NORTHSTAR ORBITAL LABS / COMPONENT ASSURANCE

Radiation Test Evidence Candidate Review Package

DOCUMENT STR-24-081 / REV A

Figure 1. Layout-realistic training graphic. Values are deliberately non-authoritative and are excluded from SPECTRA decision input.

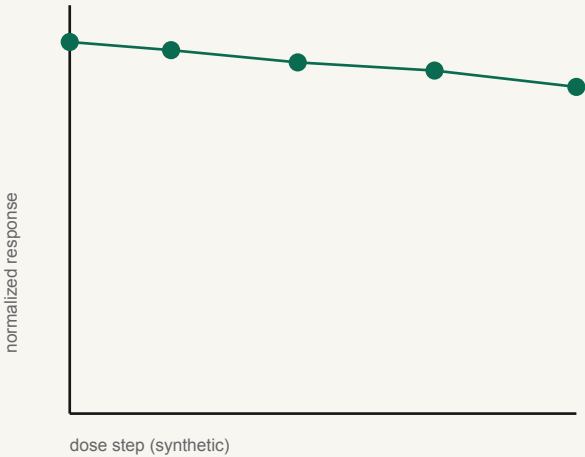
The source memo describes room-temperature irradiation of biased devices. Dose points were recorded by the test operator, but the facility certificate and dosimetry chain are not included in this package.

A functional check was reportedly performed after each exposure. The narrative mentions SEU behavior only as a follow-up topic; no event cross-section table or beam species record is attached.
